OIL CONSERVATION DIVISION

Re: Southland Royalty Company
West Corbin Federal #4
Unit H, Sec. 18, T18S, R33E
Lea County, New Mexico

RE: APPLICATION FOR PRESSURE LIMIT INCREASE FOR DISPOSAL & INJECTION WELLS

RE: *Injection Pressure Increase
West Corbin Federal Well No. 4
Lea County, New Mexico*

WEST CORBIN #4
STEP RATE INJECTION TEST

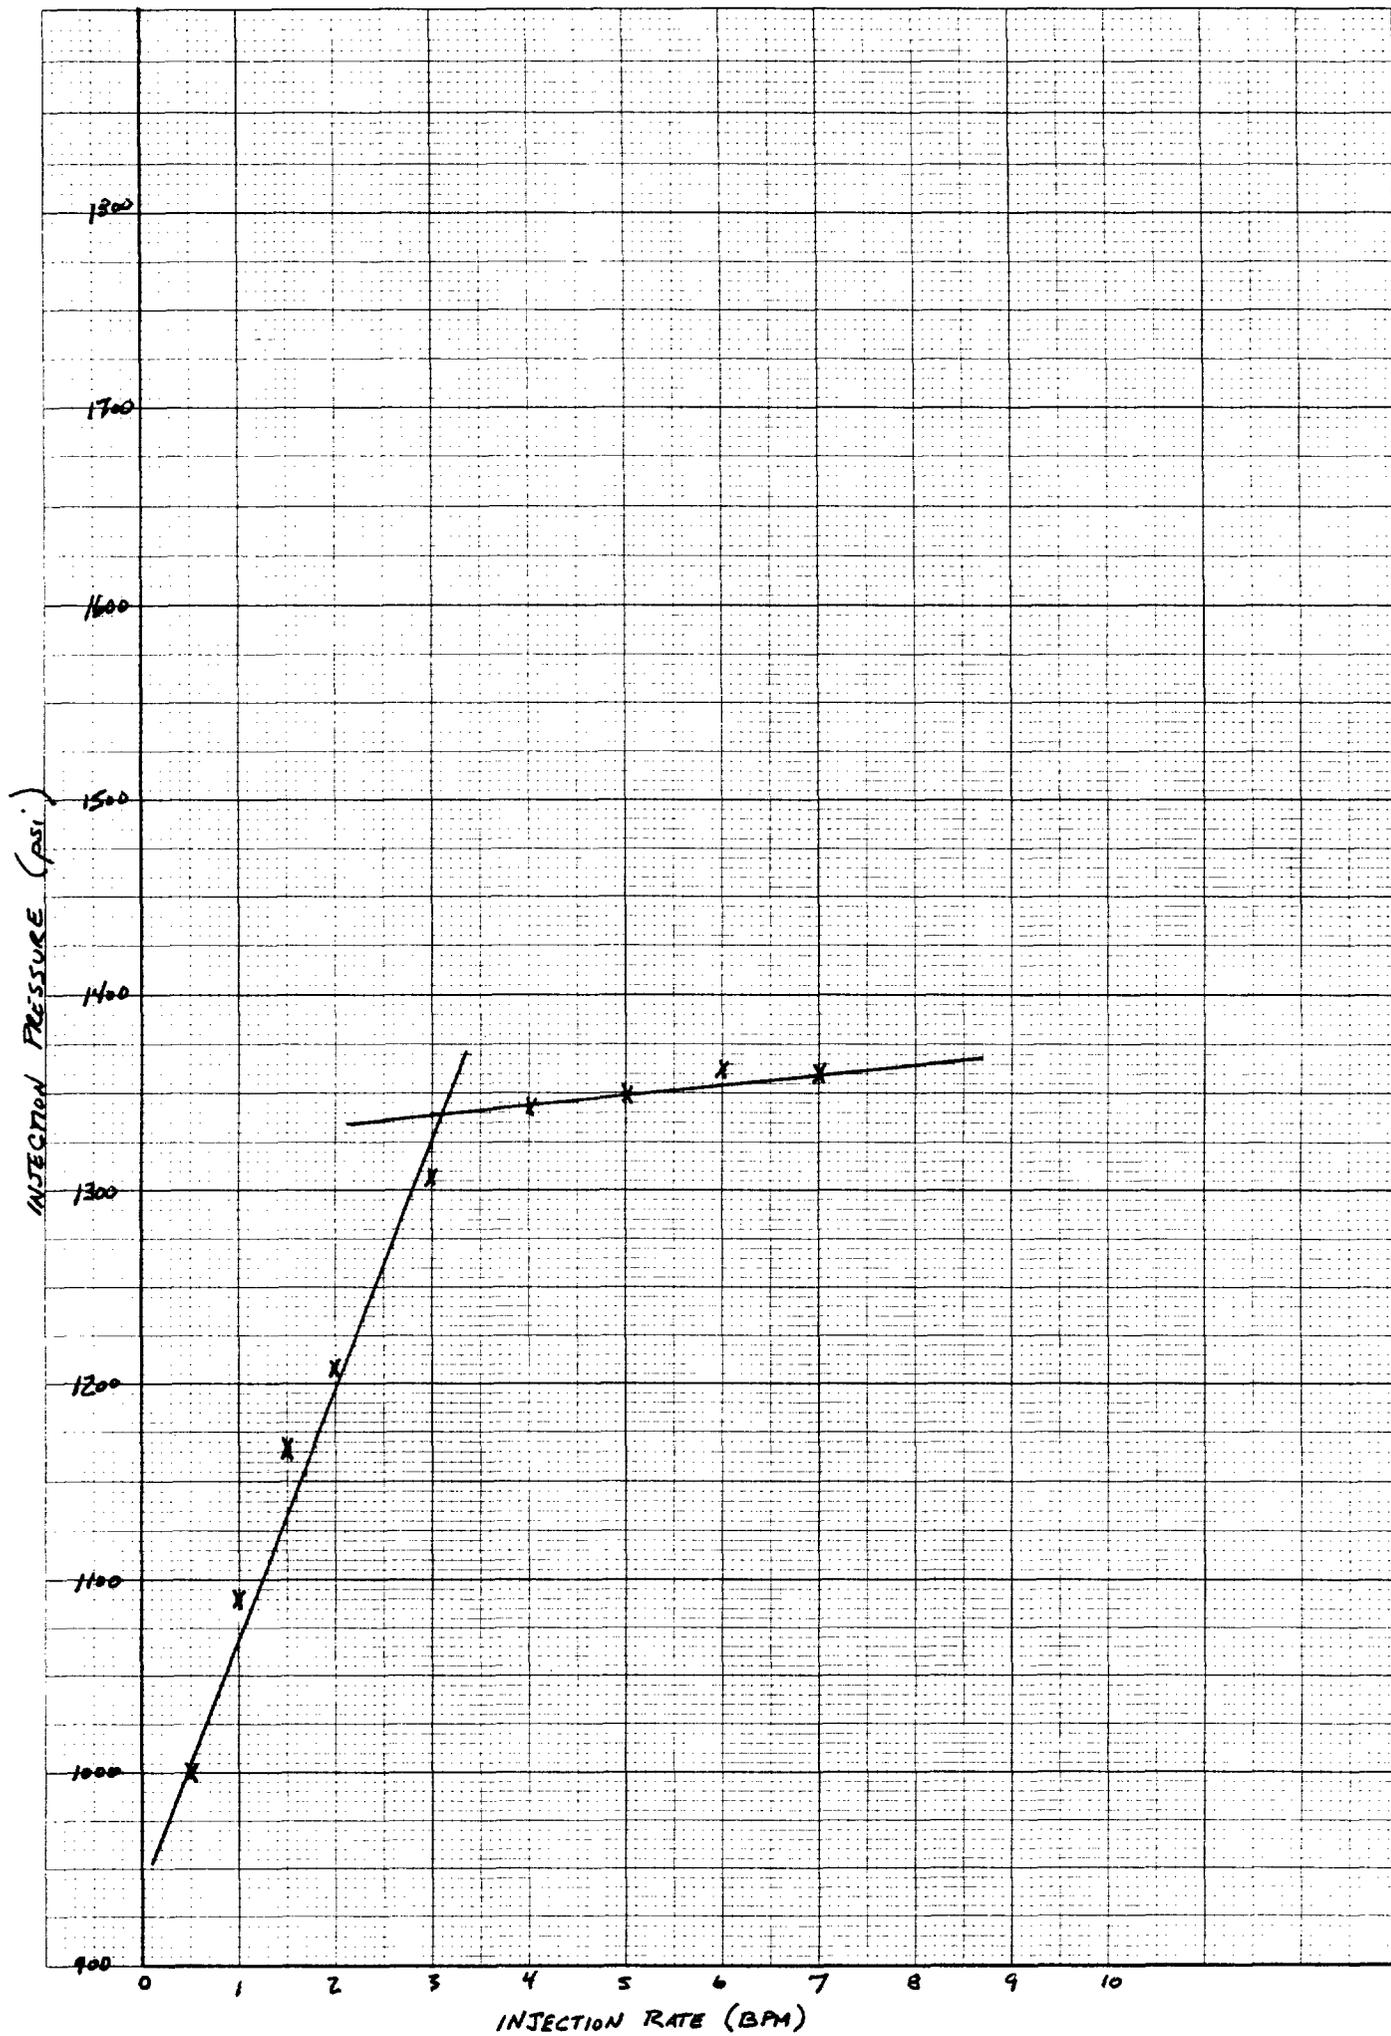
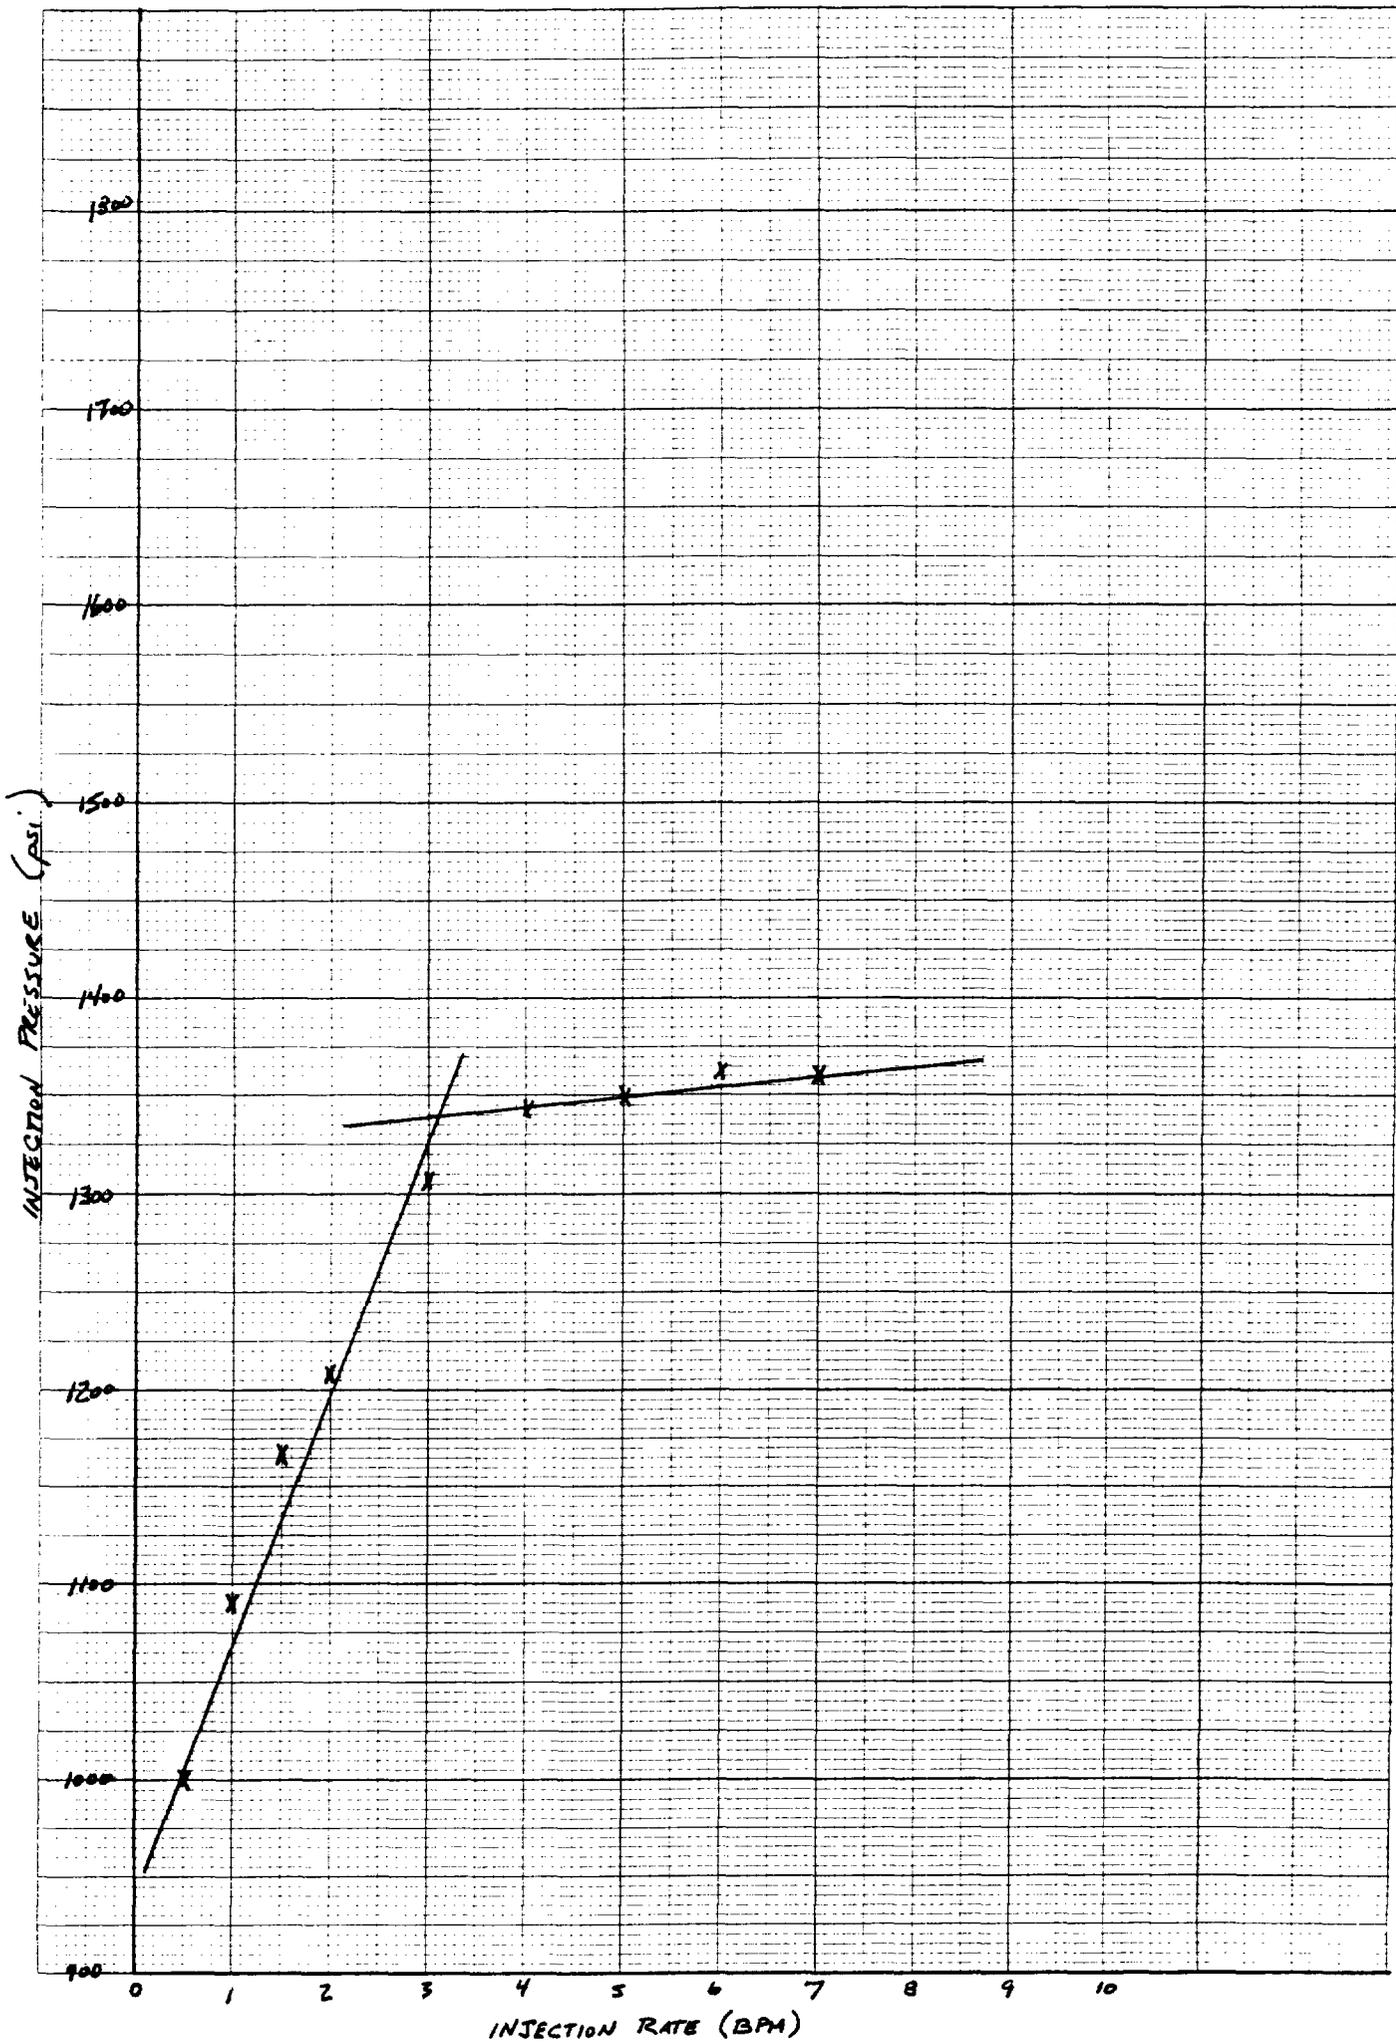
I have examined the step rate test for the:

Southland Royalty Company	West Corbin Federal (SWD)	#4-H,	18-18-33
Operator	Lease & Well No.	Unit	S-T-R

OK

Reference is made to your request dated April 2, 1990, to increase the surface injection pressure on the West Corbin Federal Well No. 4. This request is based on a step rate test conducted on the well on March 20, 1990. The results of the test have been reviewed by my staff and we feel an increase in injection pressure on the well is justified at this time.

1290 PSIG
